# UNITED STATES PATENT AND TRADEMARK OFFICE

APPLICATION NO.	FILING DATE	FIRST NAMED INVENTOR	ATTORNEY DOCKET NO.	CONFIRMATION NO.
10/623,355	07/18/2003	John Paul Mizzer	DCS-9129	5039
34500	7590	01/17/2006	EXAMINER	
DADE BEHRING INC. LEGAL DEPARTMENT 1717 DEERFIELD ROAD DEERFIELD, IL 60015			SODERQUIST, ARLEN	
			ART UNIT	PAPER NUMBER
			1743

<b>Office Action Summary</b>	<b>Application No.</b>	<b>Applicant(s)</b>	
	10/623,355	MIZZER ET AL.	
	<b>Examiner</b>	<b>Art Unit</b>	
	Arlen Soderquist	1743

Fig. 1 PRIOR ART

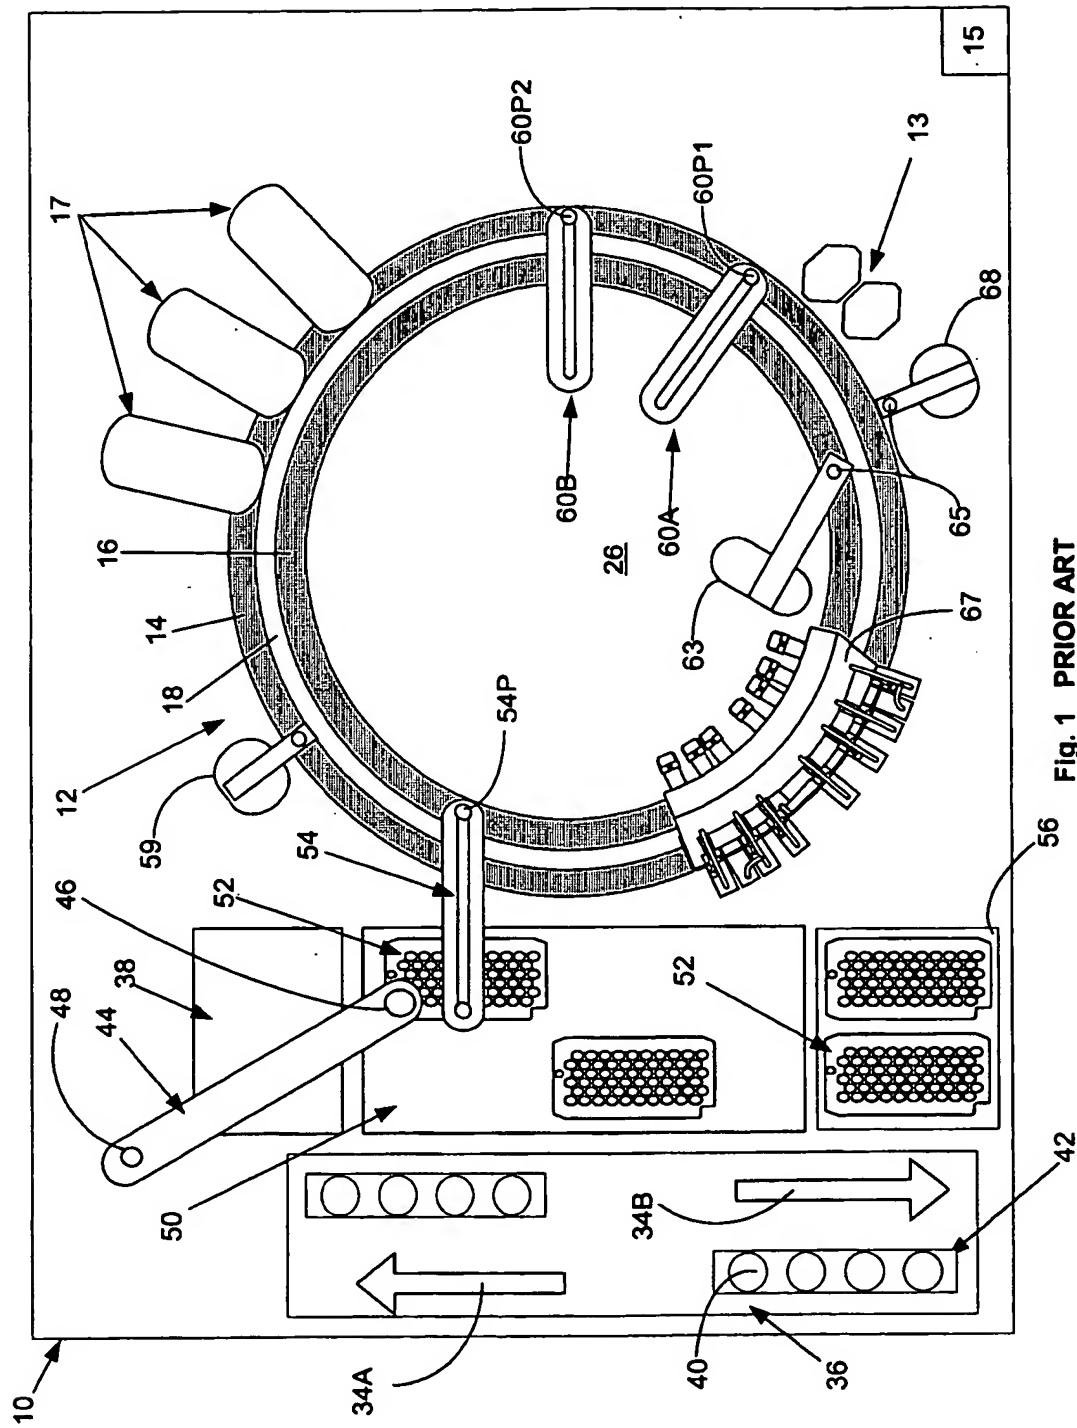
1. Figure 2 should be designated by a legend such as --Prior Art-- because only that which is old is illustrated. See MPEP § 608.02(g). Corrected drawings in compliance with 37 CFR 1.121(d) are required in reply to the Office action to avoid abandonment of the application. The replacement sheet(s) should be labeled "Replacement Sheet" in the page header (as per 37 CFR 1.84(c)) so as not to obstruct any portion of the drawing figures. If the changes are not accepted by the examiner, the applicant will be notified and informed of any required corrective action in the next Office action. The objection to the drawings will not be held in abeyance. Figure 2 is an enlargement of a portion of figure 1 which is prior art.
